## **JAFP-17-0015**

ENTERGY NUCLEAR OPERATIONS, INC.  
JAMES A. FITZPATRICK NUCLEAR POWER PLANT

EMERGENCY PLAN VOLUME 1

SECTION 2

Figure 2.4 Population Distribution by Emergency Response Planning Area

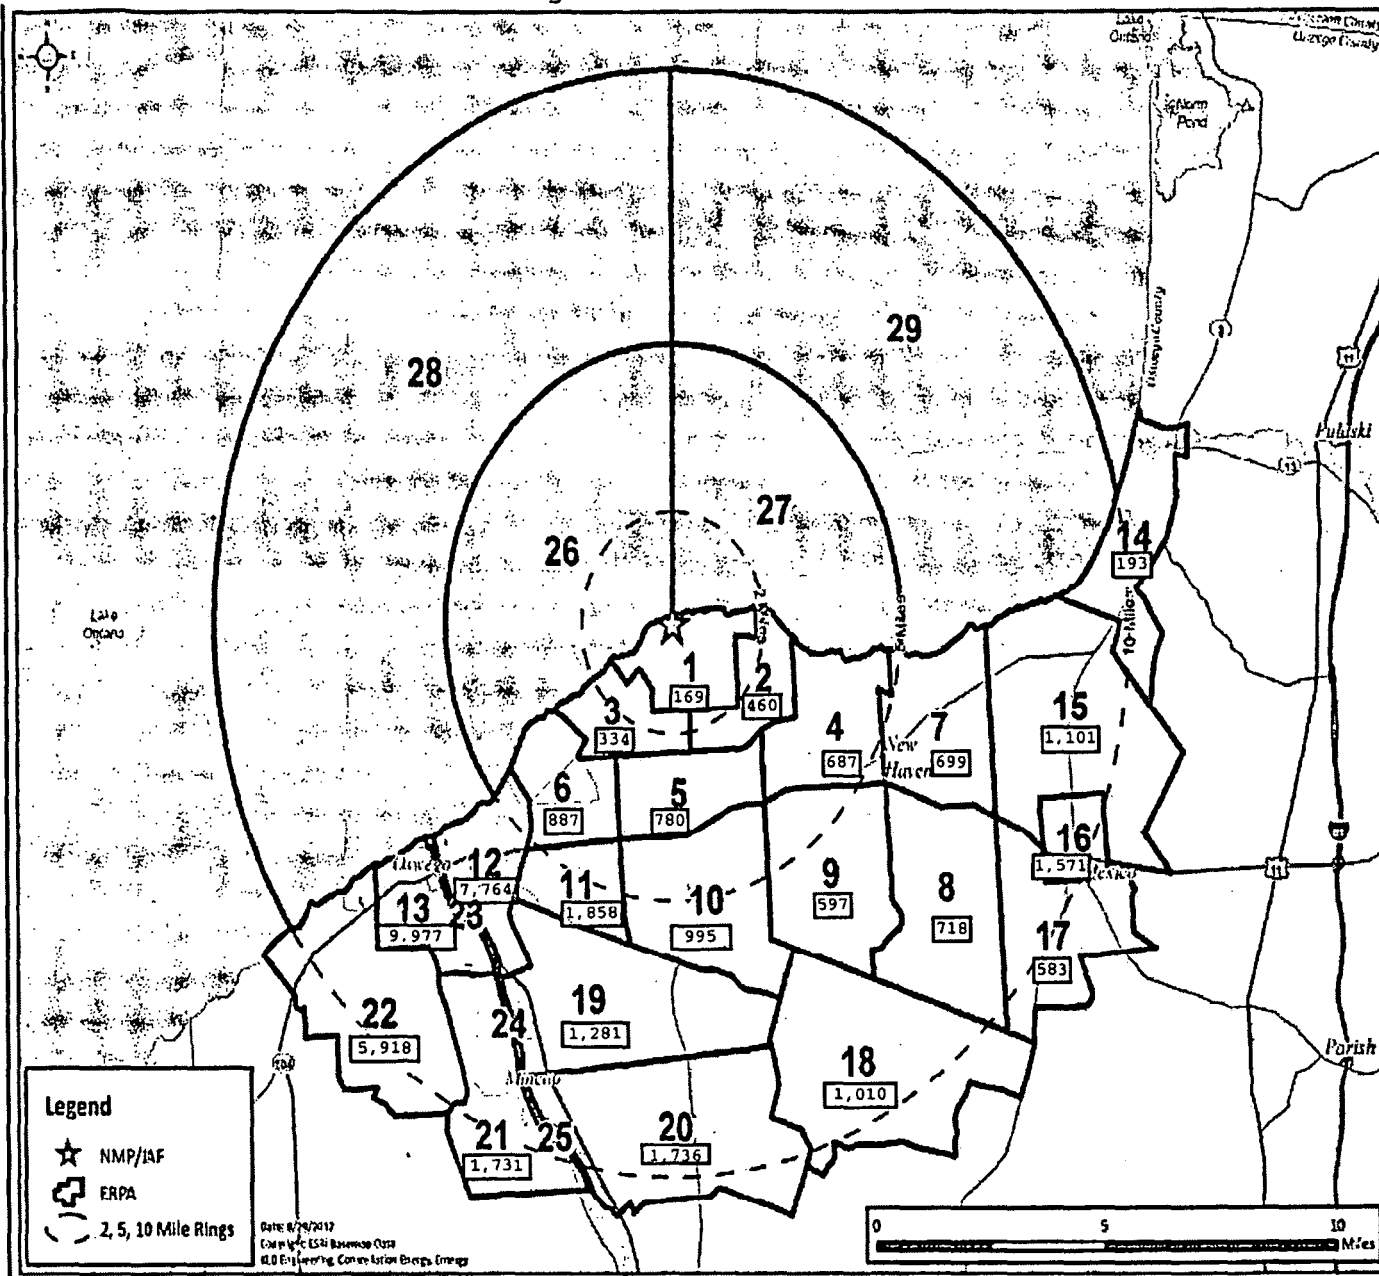
1. Adjusted cover sheet to remove signatures and OSRC information.
2. Section 2.3 - Updated numbers and descriptive information.
3. Figure 2.4 Page 2-8 - Updated to 2016 population numbers.
4. Figure 2.4 Page 2-9 - Updated to 2016 population numbers.
